Addendum No: 5  
Date: January 29, 2024  
Owner: Northern Health  
Stantec # 144320228

This addendum is to be read with and constitutes part of the tender document.

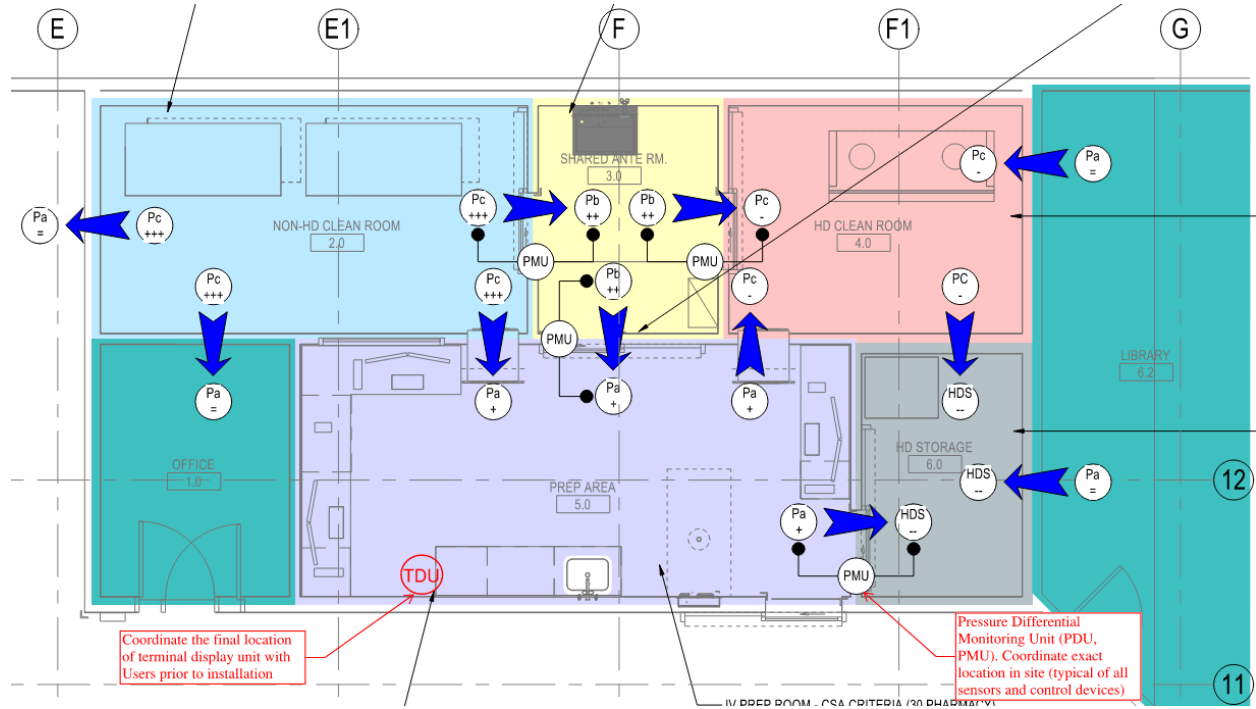
Question: Please provide the locations of the Phoenix Terminal Display Units (TDU) on drawing M100.

Answer: Refer to the sketch below for the location of terminal display unit (TDU) and pressure differential monitoring units (PDU / PMU). Coordiate the final location of all devices with Clinical prior to installation. (PMU display is preferred next to the door)
